1995 - 1996 Corvette: Service Bulletin: Delayed Engagement (Replace Pump Cover Assembly)

Subject: Delayed Engagement (Replace Pump Cover Assembly)

Bulletin Number: 67-71-48

FIGURE 3. - TORQUE CONVERTER CLUTCH SIGNAL VALVE ASSEMBLY LOCATION

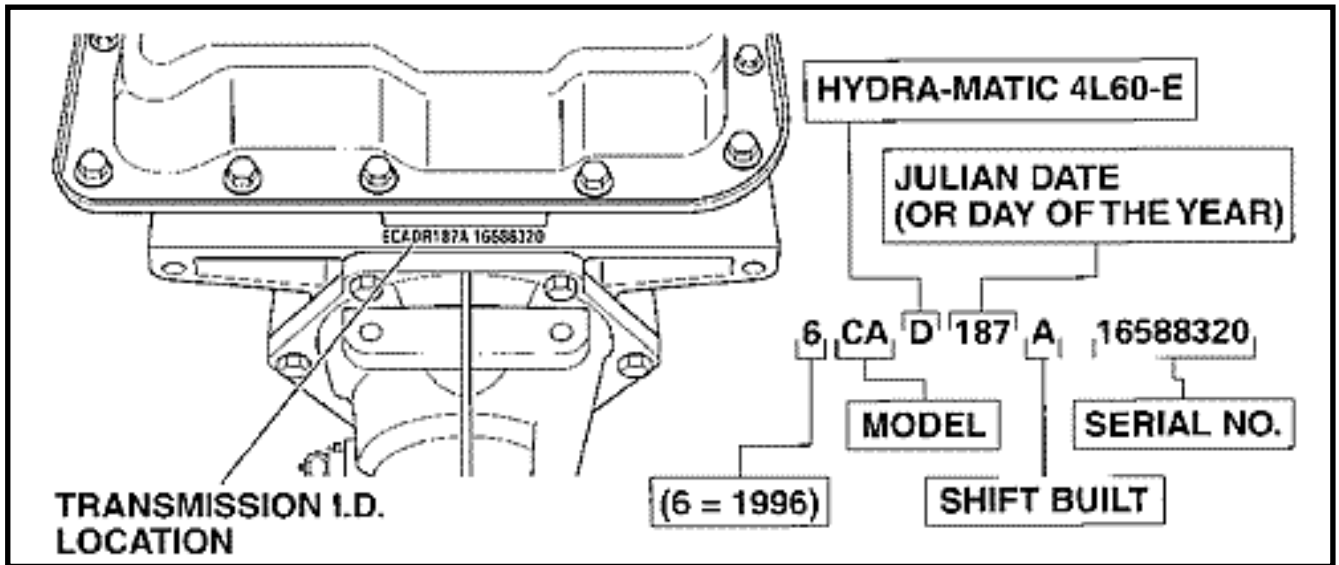
(FIGURE 3) REPLACE PUMP COVER ASSEMBLY WITH THE NEW TCC SIGNAL VALVE ASSEMBLY.

NEW PART TRANSMISSION NUMBER DESCRIPTION MODELS -----
----- 24209049 PACKAGE-COVER ASSEMBLY, PUMP ALL 1995-96
MODELS EXCEPT THOSE LISTED BELOW.

24209050 PACKAGE-COVER ASSEMBLY, PUMP
5BWD,5FFD,5YDD,6CCD,6CFD, 6KBD,6CHD,6CJD,6KCD,6BWD,
6FFD,6YDD,6WBD,6WHD
